# **Public Comments**

*November 30, 2020*  
*City Council Special Meeting*

## **Agenda Item #3**

**From:** Brooks, Elizabeth  
**Sent:** Friday, November 13, 2020 12:23 PM  
**To:** Public Comment  
**Subject:** FW: PMC, State and Federal law allows for a legal denial of the WCF application at 1307 Redwood Way  
**Attachments:** 111020 Appealant Full Rebuttal of 091420 Attachment H.pdf

Figure 1: Figure 8-2 of the draft Safety plan reproduced with additions of noted slides and erosion sites from the HDAI 1982 report

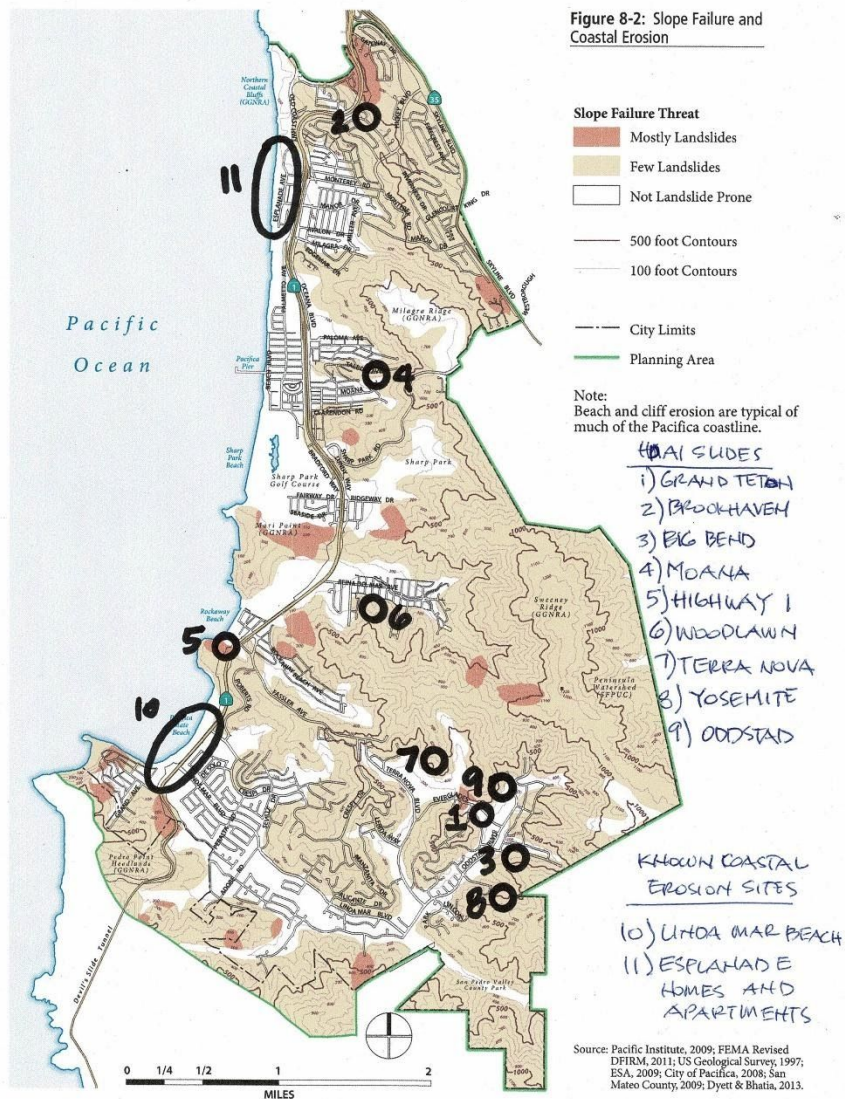
Figure 8-2 in the draft Safety Element of the General Plan Update is reproduced with additions below (Figure 1). The current maps are so devoid of real information that they are useless in assisting the city in determining hazard risks. This is corroborated by a November 18, 2020 email from Professor Jerry Davis of San Francisco State University who has extensively studied the historic slides in the San Pedro Creek watershed area.

In essence, the type of slide most common in Pacifica is not represented in the geologic maps the city uses for planning. The City has known that the geologic maps are inaccurate and not valid for use in reviewing proposed projects since 1982, and yet 32 years later, the 2014 Safety Element update still neglects to include this essential information!

Figure 2: Our Coast Our Future flooding map for Sharp Park for the scenario of 2 m Sea Level Rise and a 100 year flood.<sup>4</sup>

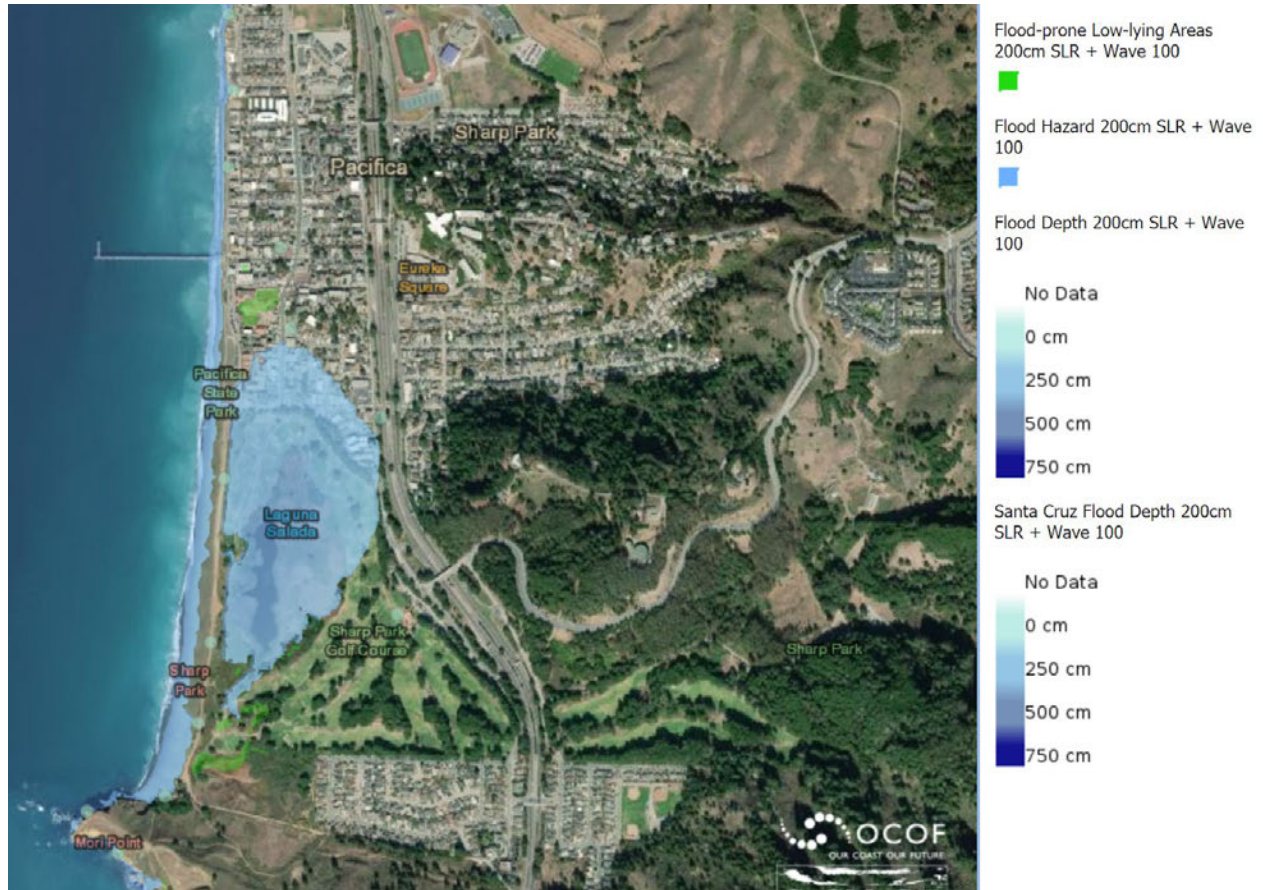
While sea level rise is not as relevant for the Vista Mar development, it was noted at the City Council meeting last week that no geotechnical or hydrological analyses of the Sharp Park area have yet been done prior to consideration of the Sharp Park Plan. The USGS's Our Coast Our Future project is a useful tool for visualizing the effects of different sea level rise and storm surge scenarios along the California coast. Figure 2 shows the results of 2 m of sea level rise and a 100 year storm surge event for the region of the Sharp Park. A significant portion of the proposed downtown development would be flooded in this medium-high risk scenario. Importantly, this does not take into consideration concurrent flooding from precipitation or local streams, which would also have to be factored in for El Niño events, for example. It seems the city is putting the cart before the horse in paying high priced consultant fees for development models that are not based on scientific facts.
